Memorandum

Toda Project

Permit 2505-202

**Mercer Island permit application 2505-202**

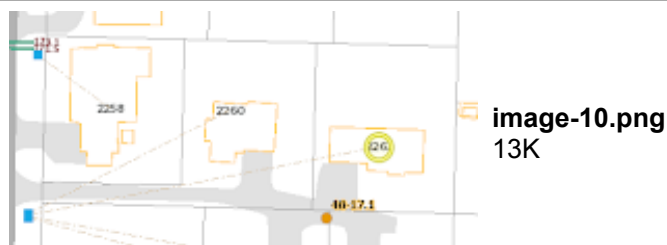
Upon review of the intake screening for this permit application, you indicated that a NFPA 13R sprinkler system is required, along with a fire code alternative. The sprinkler requirement triggered a water meter and service line upsized requirement. The site conditions for this project make that task an incredibly costly and daunting one, with the existing water meter being located at the end of the access road (see attached).

Would you accept the incorporation of a pump tank that supplies the system in lieu of supplying the system with municipal water? Will that satisfy the "fire code alternative" requirement?

Yes, a tank and pump supply is acceptable under the NFPA 13R standard. However, the system requirements are considerably more complex under 13R compared to NFPA 13D. While permissible, this setup is rarely used in single-family applications, likely due to an unfavorable cost-benefit.

Thank you for confirming that there is a 1” meter and supply presently serving the site. With that information, I suggest a code alternate proposal that includes:

1. Full-coverage 13D – this will cover all of the same areas as the MI 13R standard but requires lower flow rate that can generally be supported with a 1” supply. Here is a link to the [MI 13R standard](#). As we discussed, I recommend getting the fire sprinkler design going asap to resolve the question of a pump for the full-coverage 13D system.

2. Monitored fire alarm in accordance with NFPA 72 (Chapter 29)
3. Solid core doors throughout the residence – this only applies to bedrooms, mechanical rooms, bathrooms and laundry rooms. Closets within rooms do not need to be solid core.
4. Type-x gypsum wall board (GWB) installed on all interior walls and ceilings
